MPE720 Ver.7.86 version upgrade information

1.1 Ver.7.86 version upgrade information

The following are the items to add or improve MPE720 Ver.7.85→ Ver.7.86 functions.

No. 2 Menu-bar configuration has been changed.

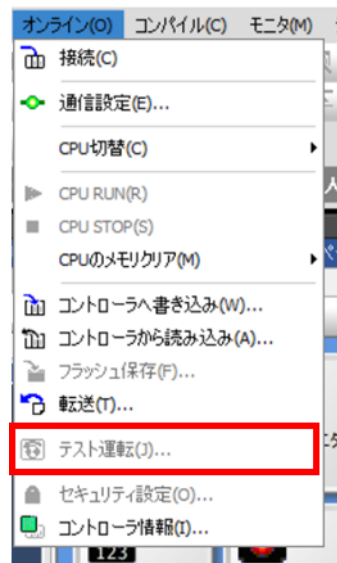
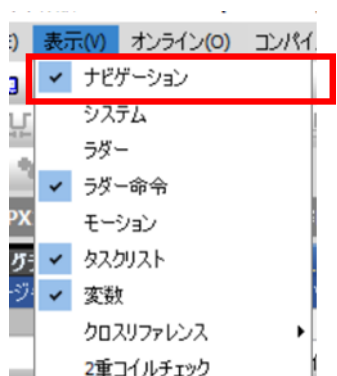
1)"Monitor" and "Tool" have been added to the menu bar items.

2)"Test operation" was added to "Online" in the menu bar item.

3)"Navigation" was added to "Display" of the menu bar item.

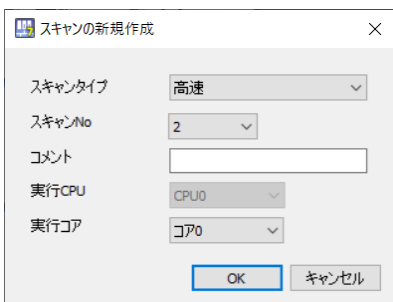
1)The navigation window was added.

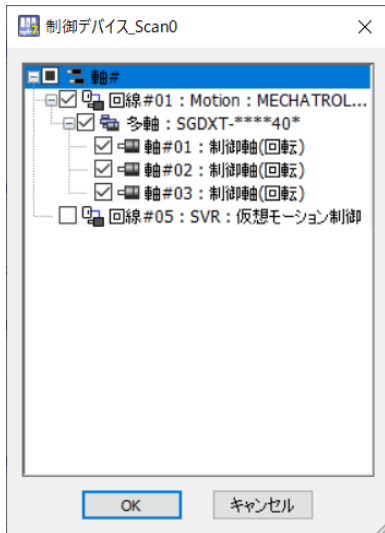
2)Scans can be newly created and deleted.

3)Register assignment can be set for scanning.

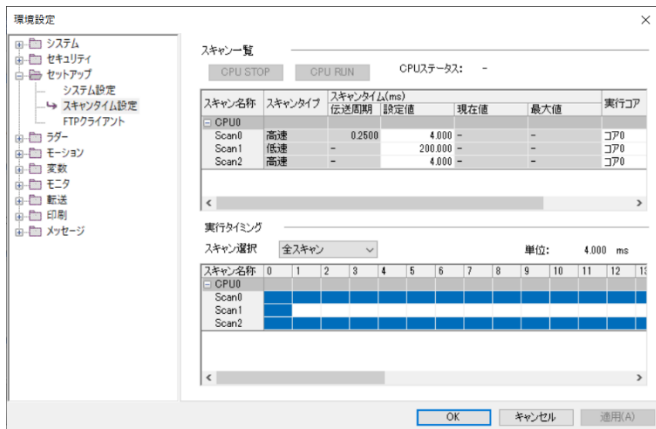
4)Control device settings for scanning are available.

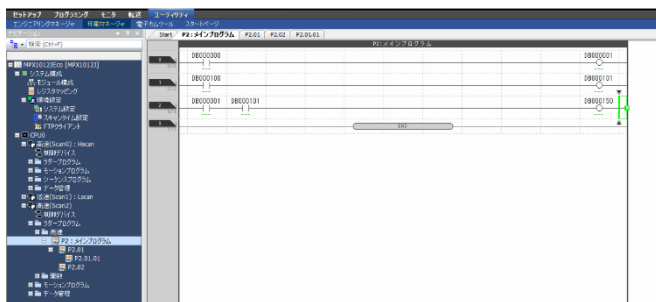
5)The scan time setting screen is compatible with the multi-scan function.

No.5 Fixed a bug that prevented FTP setting in the user control window in CPU-203 project.

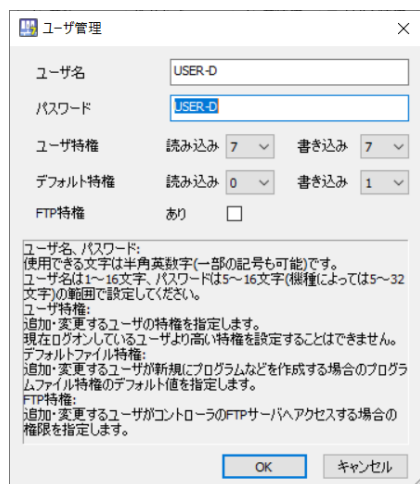
1) You can set FTP privilege on the user control window of the target controllers.

2)On the target controllers, the checking process was added so that the number of users with FTP privilege is 5.

3)Fixed a bug that could be registered when a number, ".", or "-" was used as the start character of the user name in the target controller.

No.8 Improved the bug where character string data is garbled when importing table data.

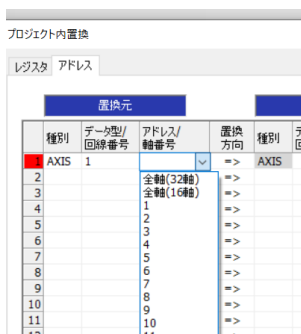
In the import of table data, there was a bug where character string data is garbled. This has been corrected.
